# UNITED STATES PATENT AND TRADEMARK OFFICE

APPLICATION NO.	FILING DATE	FIRST NAMED INVENTOR	ATTORNEY DOCKET NO.	CONFIRMATION NO.
10/757,629	01/14/2004	Mark James Kline	8194C	4664

**Office Action Summary**

# FIG. 1

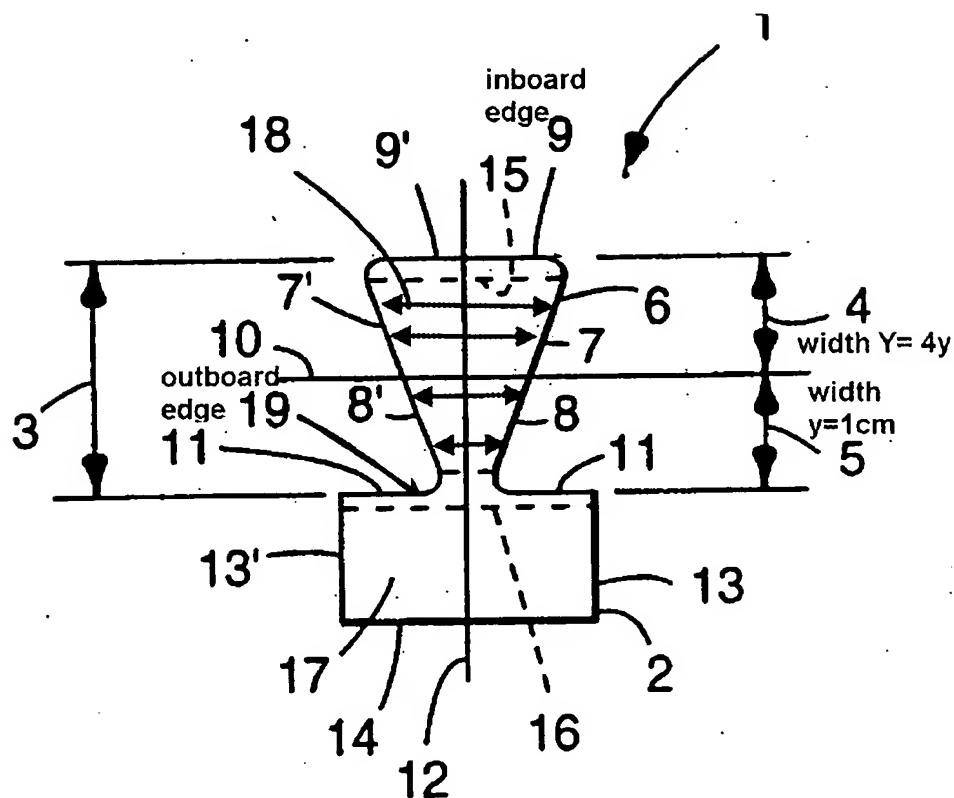
1. Claims 1-9 rejected under 35 U.S.C. 102(b) as being anticipated by Rossini et al. (US 5,312,387). Regarding claims 1-2 and 9 Rossini et al. discloses a diaper fastening tab 1 having a bond end 2 joined to article side edge and a free end 3 with a fastening surface 18, the fastening tab 1 having an effective dimension Y extending parallel to a longitudinal axis, the effective dimension Y increasing from a laterally outboard edge 19 to a laterally inboard edge 9 of the first surface, wherein the surface fastening system has peel maximum/different levels of resistance to disengagement at the distal half 4 of free end 3 (col. 2, ll. 31-39, 43-47, col. 4, ll. 1-8 and figure 1).

Regarding claims 3-4 Rossini et al. discloses a fastening element with a longitudinally inboard edge 9 longer than longitudinally outboard edge 19 (fig. 1).

Regarding claim 5 Rossini et al. discloses inboard edge 9 having free end 3 being unjoined from the article (col. 2, ll. 43-45 and fig. 1).
